Appellant's Exhibit 100

*Appellant WPDC Cleveland LLC's Witness and Exhibit List*)

**From:** Sean Miller <sean@origins.sale>  
**Sent:** Thursday, April 27, 2017 10:08 PM  
**To:** Morris Architects; Jozanne Moe  
**Subject:** Re: Roof access

**1 FLOOR PLAN**

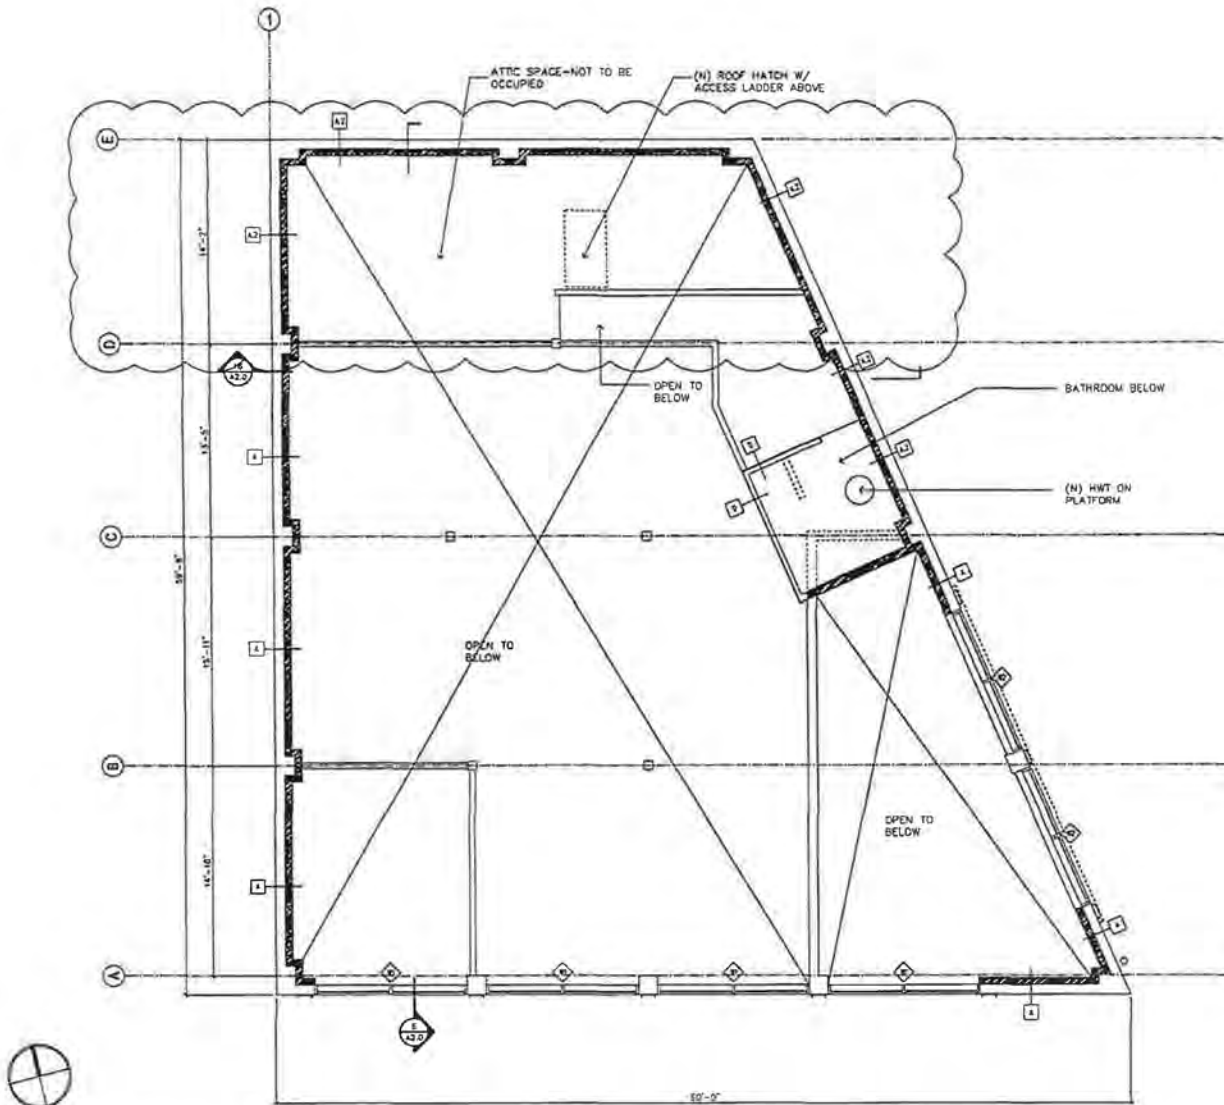
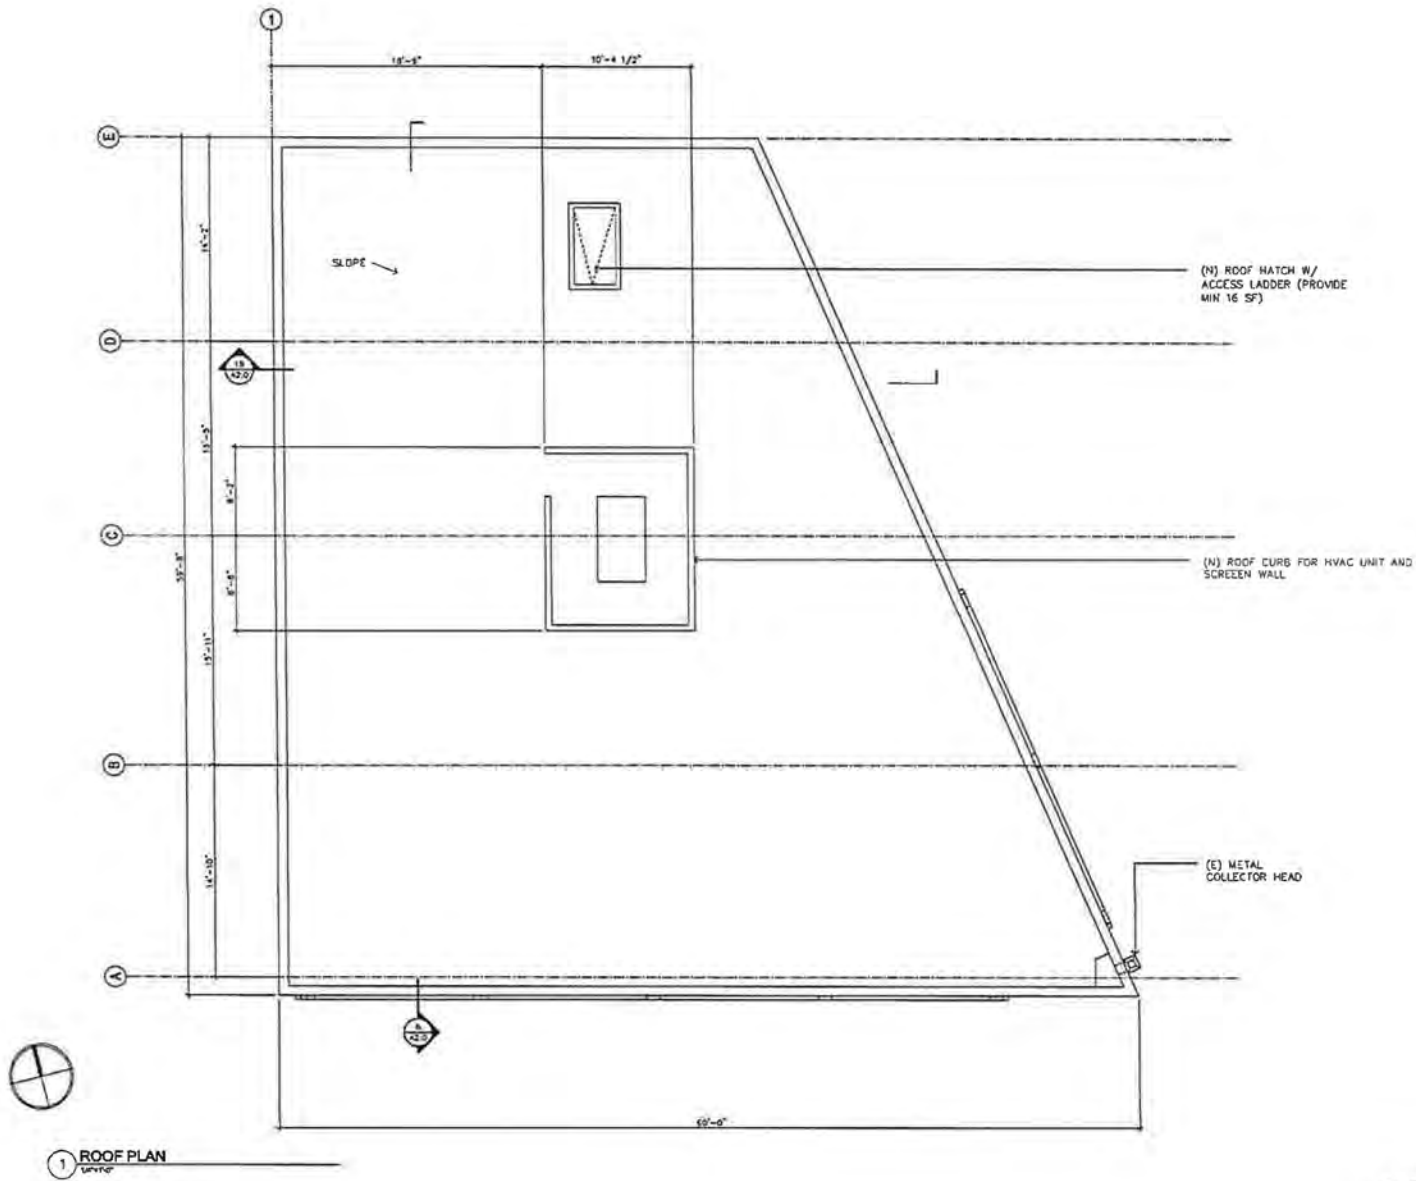
Here are plans and sections indicating our intention to remove the use of the mezzanine, but to utilize it to access the roof hatch.

In our case, this roof hatch was to be accessed from the mezzanine (now being eliminated). Are we permitted to develop a landing on the clg joists, to allow for a ladder to the roof?

Hi Tom,  
Per the mechanical code a fixed, built in ladder or something similar needs to be installed in the interior of the building for roof access. I hope this helps, if not let me know.  
Thanks,

I would read it that a ladder can be used. You meet the exception and you are not a building four or more stories and you don't have elevator equipment. Let me run this by the inspector and I will get back to you tomorrow.

5 BUILDING SECTION

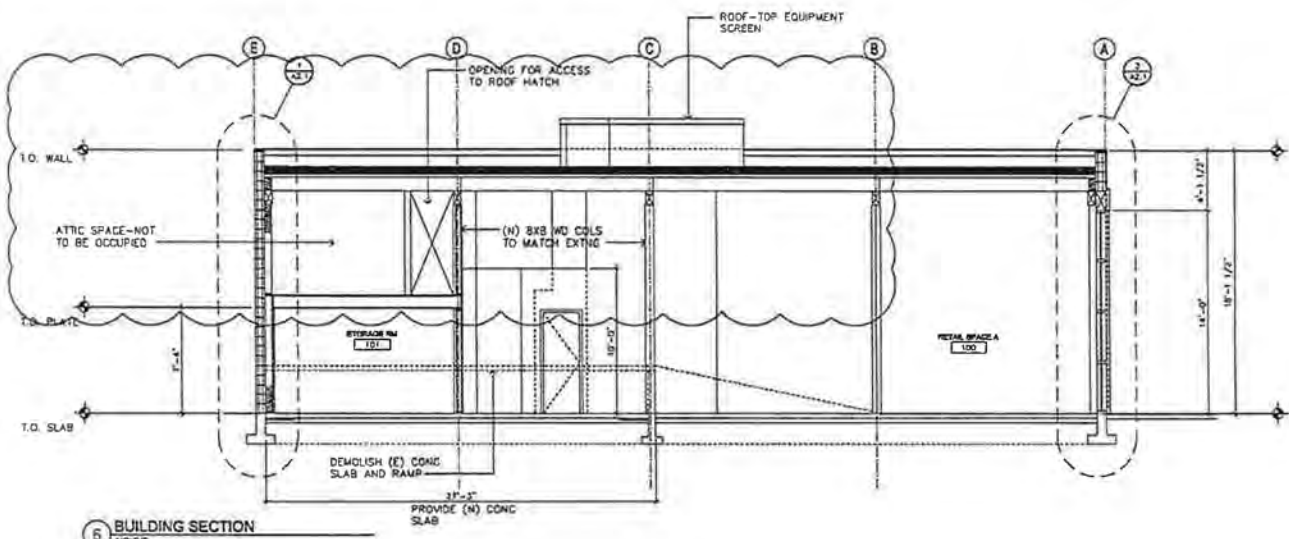
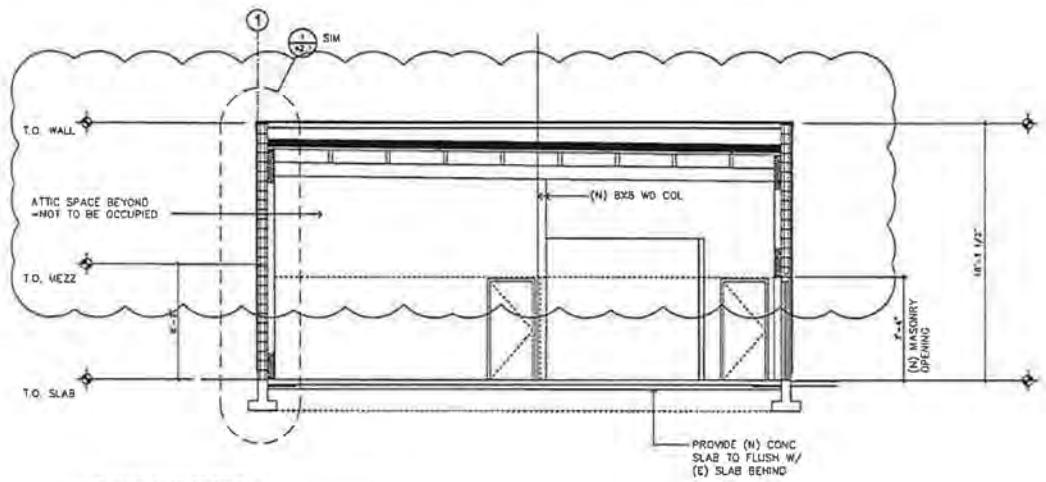
Thank you Jozanne. There will be 2 ladders, one from the main floor to the vacated mezzanine, and one to a roof hatch. Will this work?
